**Re: Scone Subdivision Stormwater Management Plan  
Response to Northrop Peer Review**

ACOR Stormwater Management Plan for Development Approval was prepared for proposed subdivision at Gundy Road Scone. Revision 1 of the report was issued on 19 August 2021. A peer review of the Stormwater Management Plan was undertaken by Northrop. Refer to Northrop letter titled *"Review of Stormwater Management Plan at 150 Gundy Road, Scone"*, and dated 19 January 2022 with a reference number NL213311.

Figure 2. The Strahler System

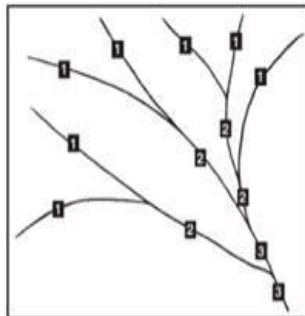
- *Definition of riparian extents should be prepared and placement of Water Quality devices in accordance with NRAR Controlled Activities on Waterfront Land guidelines should be reviewed.*

**The riparian extents have been added to the figures in accordance with guidelines for second order stream as detailed below.**

**The stream is Second order and requires 20m riparian buffer either side of formal channel.**
